PLANNING NMA-CHANGE LIST		
ID	Proposed Changes to plans that are 'Non Material'	Reason for 'Amendment'
A	Changes to Common stair towards compliance for general access where a clear landing needs to be provided and to accommodate smoke control. Circulation area and internal doorway to stairs rearranged to adapt corridor aisle. Stairs, structurally stacked for construction leading towards the corridor or lobby next to the stair being provided with a smoke vent and a store area provision on ground level. Rearrangement in plan due to the above visible on the Northwest facade. Window openings, adapted to suit mentioned changes/rearrangement.	Compliance towards Building Regulations, Part-K-Protection from falling, collision and impact and Part-B-Fire safety
B	Changes to Communal lifts and stairs towards compliance for firefighting where a firefighting shaft is required as the building is over 18m and to accommodate smoke control and building services. Circulation area internal doorway to stairs and clear landing for lifts rearranged to adapt corridor aisle. Stairs, structurally stacked for construction leading towards a vertical smoke shaft that opens at roof level with rationalised comm

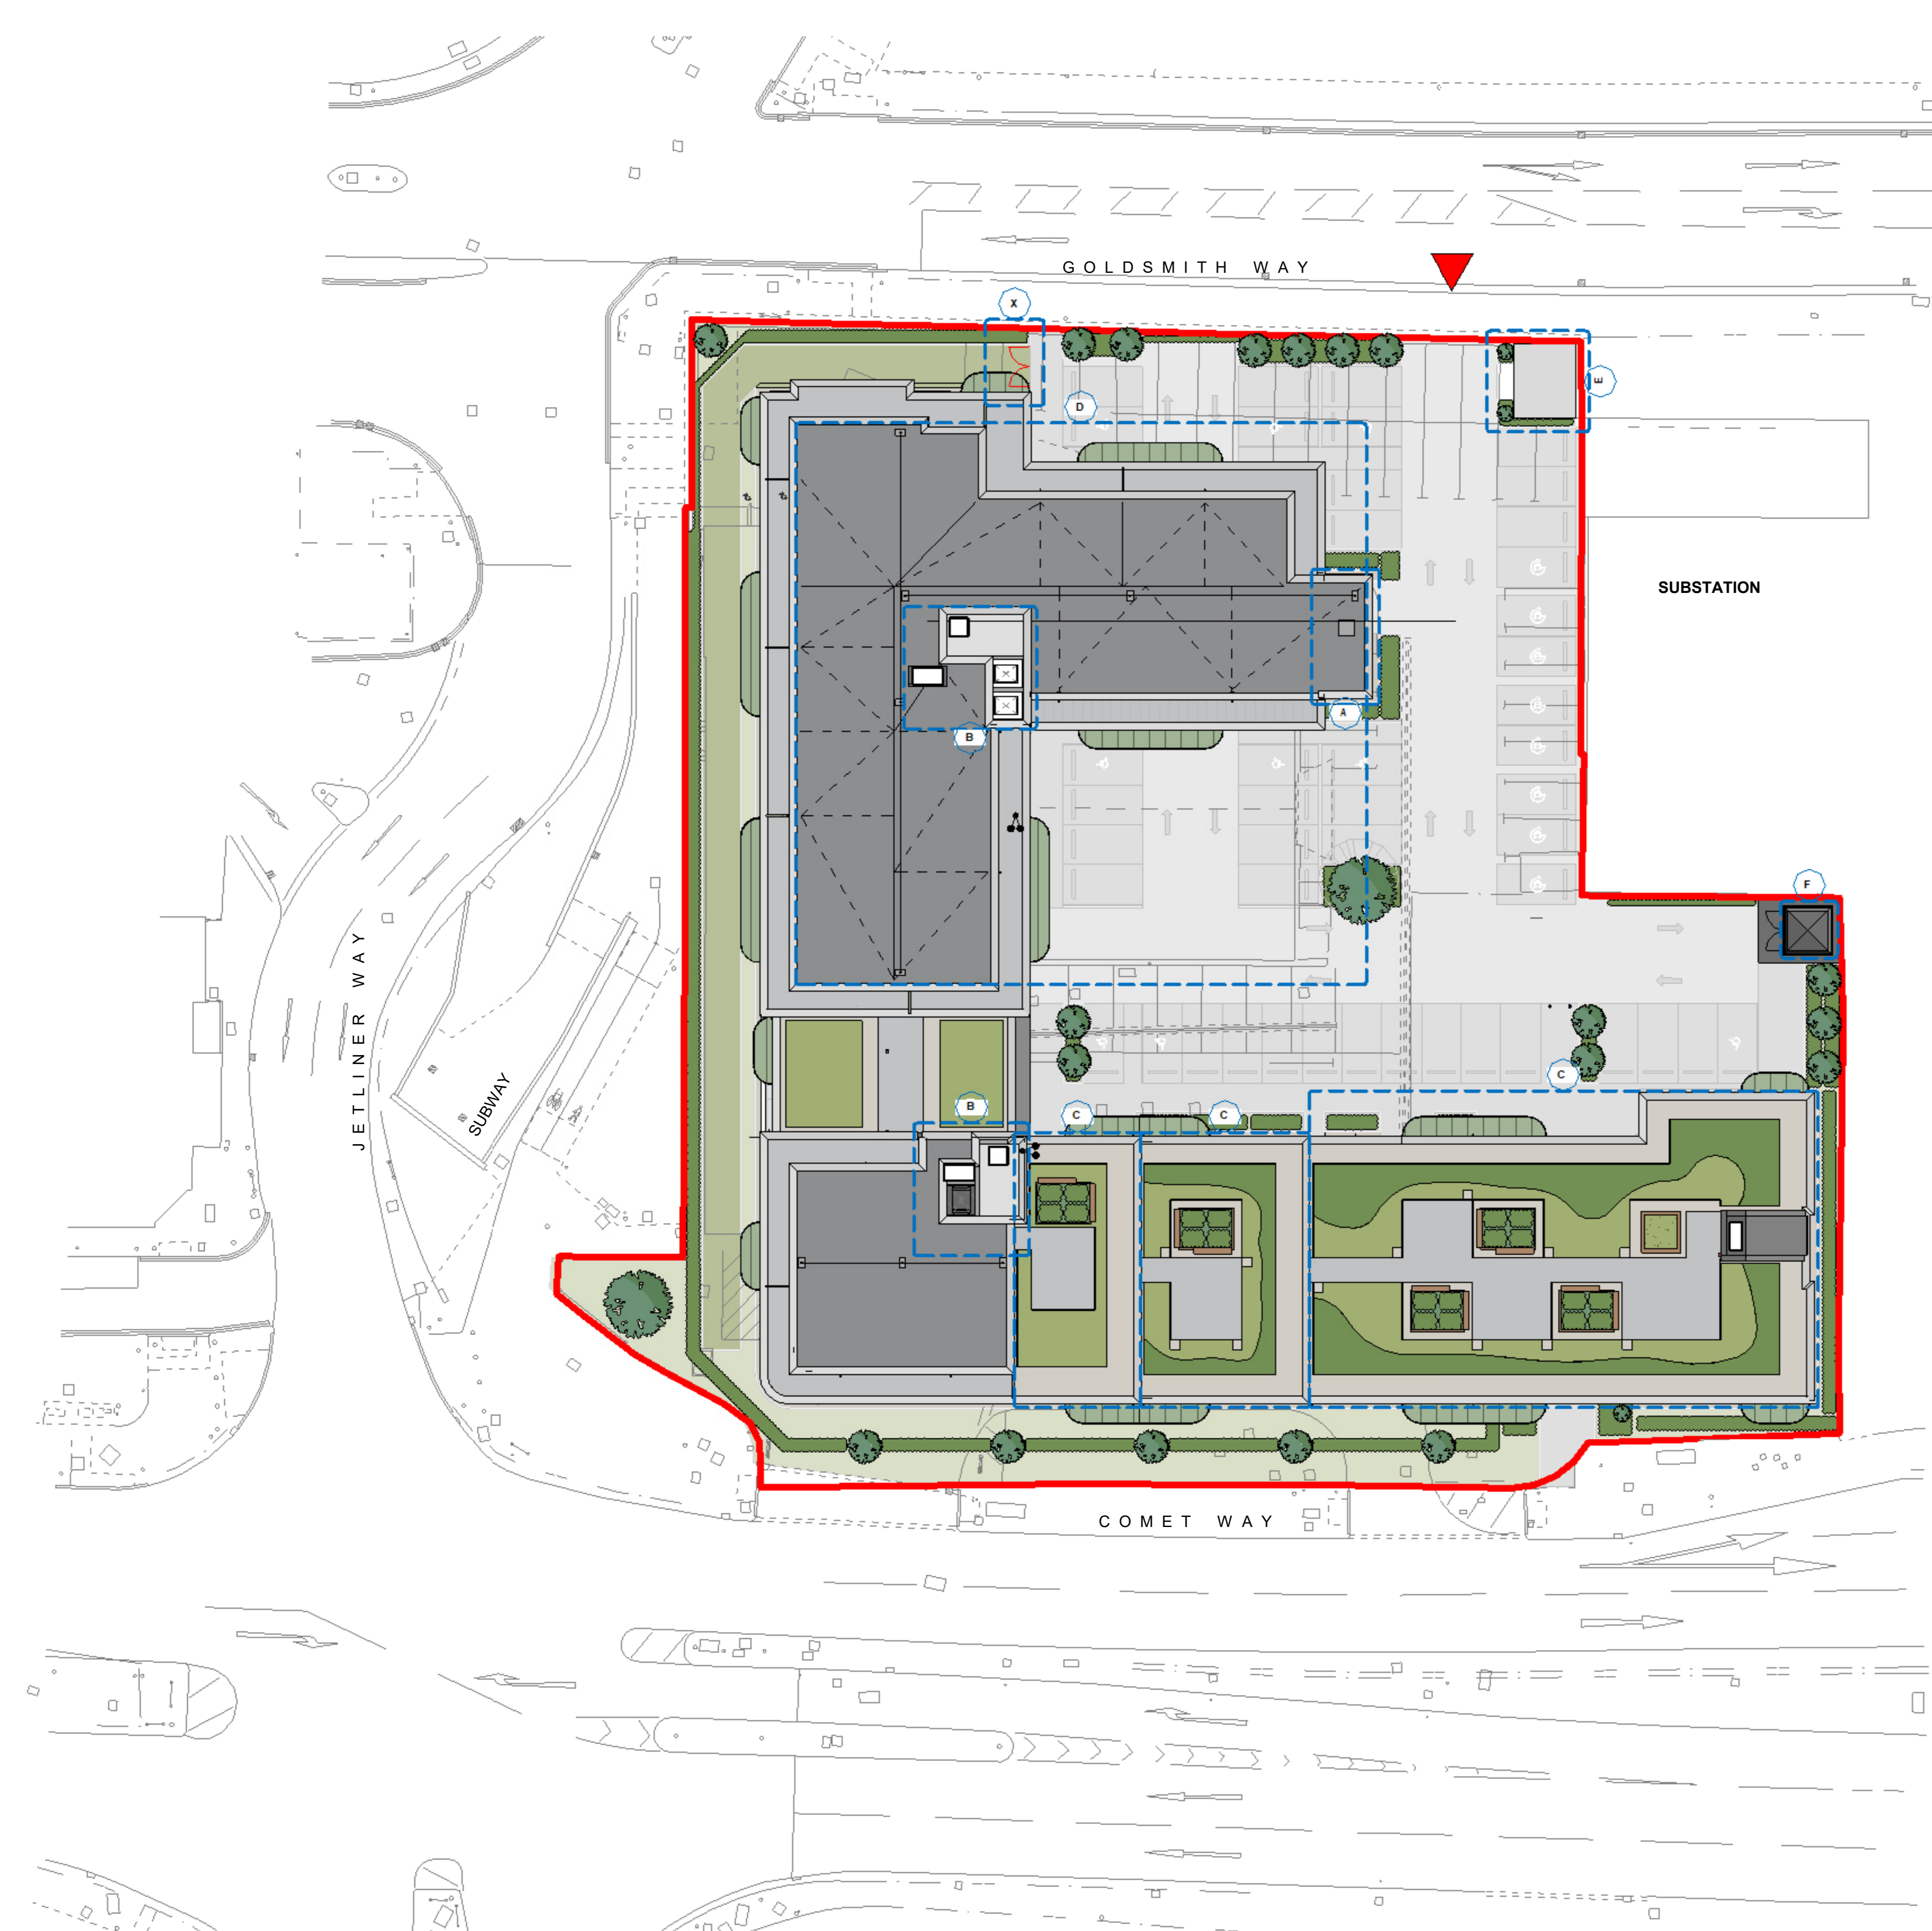
C	Changes to communal roof gardens (landscaping) including change of barrier type (railing) from glazed balustrade to counterbalance metal railing.	To contribute positively towards biodiversity via balance of soft and hard landscaping schemes including provisions for bird and bat boxes, whilst maintaining overall uniformity for railing type.
D	Removal of photovoltaic (PV) cells on the roof	PV was not required as Part L requirement was met using Exhaust Air Heat Pumps.
E	Relocation of Substation and provision for Generator in allocated space.	Provision for separate secluded area for generator
F	Changes to provide new location for UKPN Substation	Provision for future relocation for UKPN Substation
G	Changes to ground level Cycle store to accommodate building services plant rooms including removal of two openings with rearrangement of the remainder openings.	Provision towards Building Services, Secondary LV switch room and Corms room.

H	Changes to ground level Cycle store to accommodate building services plant rooms including removal of two openings with rearrangement of the remainder openings.	Provision towards secure access and splitting into 4 small bin stores to comply with recent update of having maximum 8 large (1100lbs) receptacles within.
J	Removal of Cycle store area and Bin store area at ground level, including external door in cycle store area towards provision to accommodate building services plant room including clear vehicular access towards undercroft parking.	Provision towards Building Services, Primary LV switch room and vehicular access towards undercroft parking.
K	Changes to ground level facade including removal of two openings to accommodate communal letter boxes with rearrangement of the remainder openings with provision for accessibility.	Provision towards communal letter boxes
L	Removal of undercroft parking entrance/exit at ground level towards provision for Relocation/Retainment of existing UKPN Substation, whilst adding double doors as per change ID C-05.	Provision towards single point of entry/exit for undercroft parking and towards relocation/retainment of existing UKPN Substation mentioned in change ID-E

M	Changes to ground and first floor level, Common stair for means of fire escape and to accommodate smoke control to circulation area. Circulation area and internal doorway to stairs rearranged to adapt corridor aisle. Stairs, moved away from corridor aisle leading towards provision for an external smoke vent at first floor level. Rearrangement in plan due to the above visible on the Northeast facade. Ground level escape door, adapted to suit mentioned changes/rearrangement.	Compliance towards Building Regulations, Part-B-Fire safety.
N	Changes to ground level Cycle room and adjacent Store to replace provision for Cycle store area as per change ID C-09 via consolidation. Rearrangement in plan due to the above visible on elevations.	Provision towards replacement of removed cycle store mentioned in change ID-J.
P	Changes to Communal lift and stairs towards compliance for general access where a clear landing needs to be provided and to accommodate smoke control and building services. Circulation area internal doorway to stairs and clear landing for lifts rearranged to adapt corridor aisle. Stairs, structurally stacked for construction leading towards covered and enclosed stair at roof fourth floor level with rationalised communal entrance/exit. Rearrangement in plan due to the above visible on elevations.	Compliance towards Building Regulations, Part-K-Protection from falling, collision and impact, Part-B-Fire safety and Provision for stair enclosed/walkway that is directly covered.

Q	Changes to ground level Bin store arrangement to replace Bin store as per change ID C-09 via consolidation and enlargement to provide building services plant room. Rearrangement in plan due to the above visible on elevations.	Provision towards replacement of removed Bin store mentioned in change ID-J and provision for BCW Tank room.
R	Changes to ground level openings, facade screens from circular pattern metal screens/vents to vertical extruded aluminium flats metal screen that match the railing type, including removal of one opening that clashes structural column on the comet way elevation.	To maintaining overall architectural uniformity and structural framing.
S	Removal of Green Wall as they do not comply with fire safety regulation 7(2).	Regulation 7(2), requires all residential blocks with top storey heights over 18m to have all materials which become part of an external wall or specified attachment (e.g. balconies) to achieve class A2-s1, d0 or class A1, except for materials which are exempt as per regulation 7(3). Additionally, membranes used as part of external wall construction above ground should achieve a minimum of class B-s3, d0.

T	Changes to storage area, rearrangement towards desired storage required.	Provision towards desired storage required.
U	Discrepancy error on Comet way elevation whereby two window openings depicted would not have been located on the fifth-floor level plan as these would intrude privacy for the bathrooms.	Discrepancy error
V	Removal of single window, recessed brick reveals on the Northeast elevation.	The recessed brick reveals is towards the left of a single pane window for levels 1-4, whilst it changes to a double pane for level 5. To maintain architectural uniformity, we have detailed a constant double pane window for all levels.
X	Private path on western site boundary	For Façade maintenance MEWP access.
